**ITB 2020-108  
CONSTRUCTION OF PROGRAM SPACE  
CALVERT COUNTY DETENTION CENTER  
BARSTOW, CALVERT COUNTY, MARYLAND**

**QUESTIONS AND ANSWERS/CLARIFICATION NO. 2**

2 SECTION  
 SCALE: 3/4" = 1'-0"

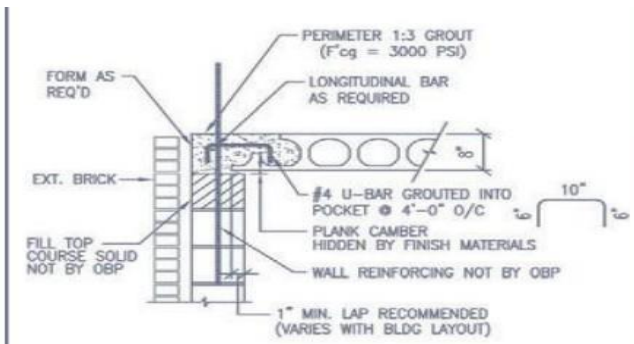
5. Section cuts 2 and 7 on S202.

Oldcastle has stated they will not add this bar but their standard details D21 & D22 which show a u-bar connection. Will this be acceptable? **This is acceptable.**

D123.0 Header Support at Large Opening

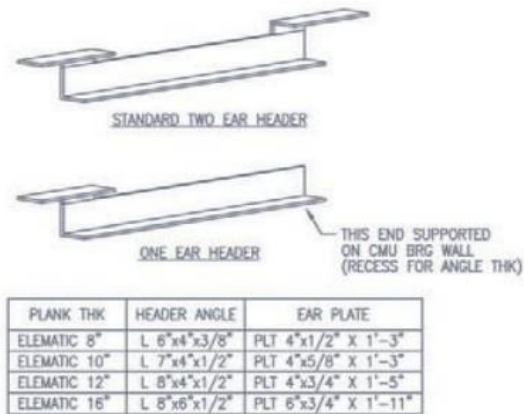
For section 7 Oldcastle do not recess their planks for the headers and this would be excluded from the scope, please reference D123 & D124 Will this be acceptable? **This is acceptable.**
